#### 1. Problem Stated by Highway Authority at Identified Location

# 3.2 Proposed Advisory Cycle Lane width

## 4.1 Context and Continuity of Route

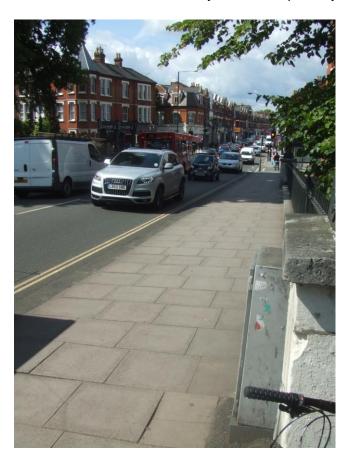
"...the proposed lane does not link to anything at either end. There's a shared use path on the footway in Rosslyn Road at the junction with Richmond Road: can't the proposed cycle lane be extended west to link to it rather than starting further along Richmond Road?"

"Richmond Bridge is a problem without an easy solution (a pedestrian Eton Street?) Accepting it's too narrow for a cycle lane implies it's too narrow for other vehicles to overtake cyclists safely. Some means of indicating to cyclists they should "take the lane" and to drivers that they should expect cyclists to do so is needed."
